## OCP NIC 3.0 Design Specification

Version 0.01

Author: OCP Server Workgroup, OCP NIC subgroup

Figure 4: Example Small Card Form Factor

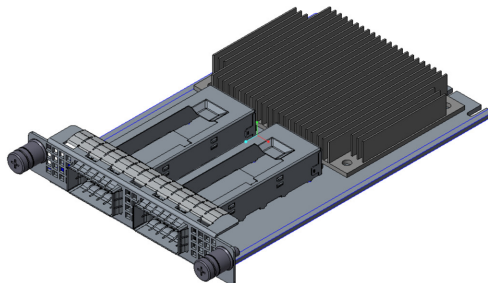
**Commented [TN2]:** Are we going to uprev the SFF-TA spec to include these 28 pins?

Figure 6: Primary Connector (4C + OCP Bay) with 4C and 2C Add in Cards

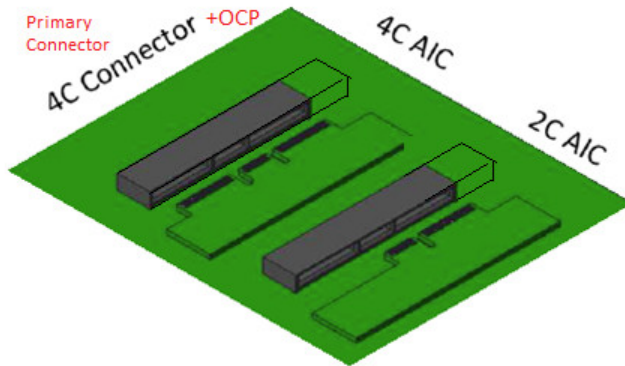
**Commented [TN3]:** This needs to be updated to show the OCP bay along with the secondary connector location..

Figure 7: Small Size Primary Connector Gold Finger Mating Card Dimensions – x16 – Top Side

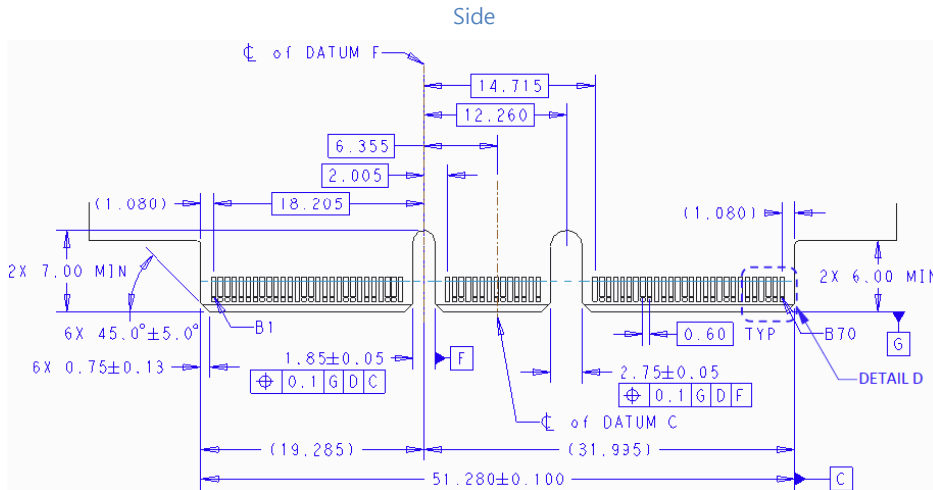
**Commented [TN5]:** Drawing was pulled from SFF-TA-1002 FIGURE 5-18.

Figure 9: Small Size Secondary Connector Gold Finger Mating Card Dimensions – x16 – Top

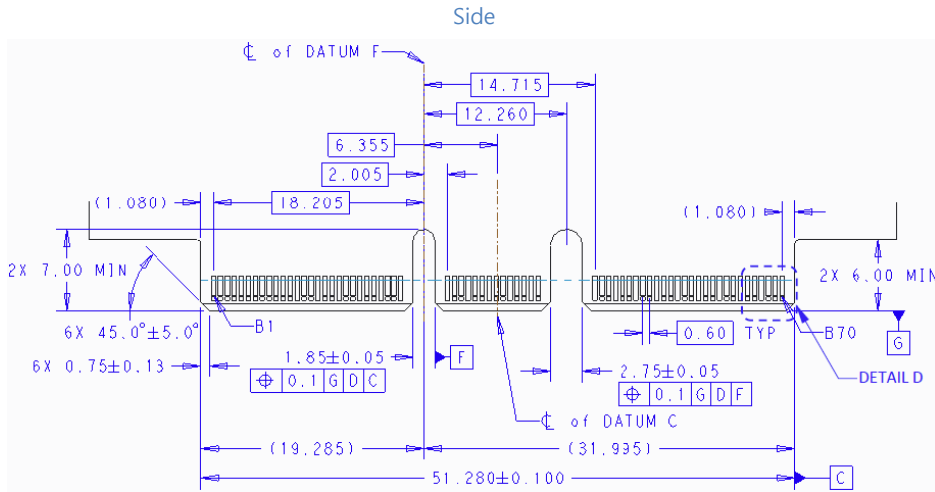
Commented [TN7]: Drawing was pulled from SFF-TA-1002 FIGURE 5-18.

Figure 19: NC-SI Over RBT Connection Example

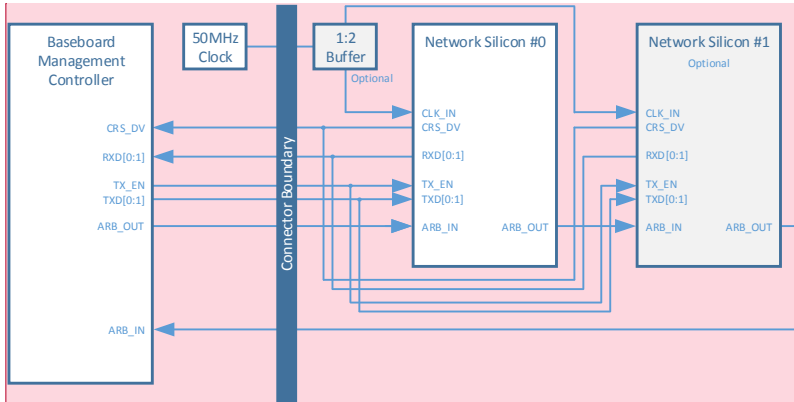
**Commented [TN17]:** Update this diagram. The ARB\_IN and ARB\_OUT on the host side should either: 1) connect to each other to complete the ring, or 2) connect to an a second Primary Connector slot.

Also, show an implementation that has two Primary Connectors with RBT connected.
